Access Compliance Report

Public Rights-of-Way

Intersection ID: 14212	Main Street: HAWKINS_ST	Cross Street: W_TREMONT_AV	Location: SE
ADA ID: A6E9D03E9B95	Ramp Type: BlendTrans1	Initial Pass/Fail: Fail	Overall Compliance: No
		Severity Score: 8.75

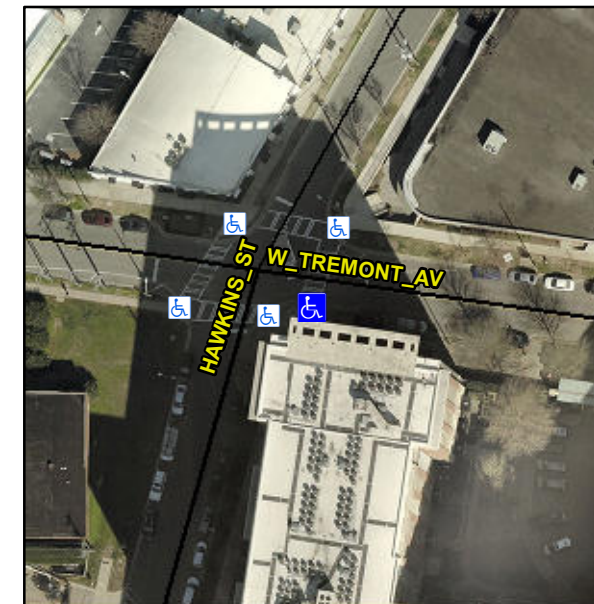
Possible Solutions:

Remove & Replace Curb Ramp With Two New Directional Ramps or Equivalent.

R304.5.1
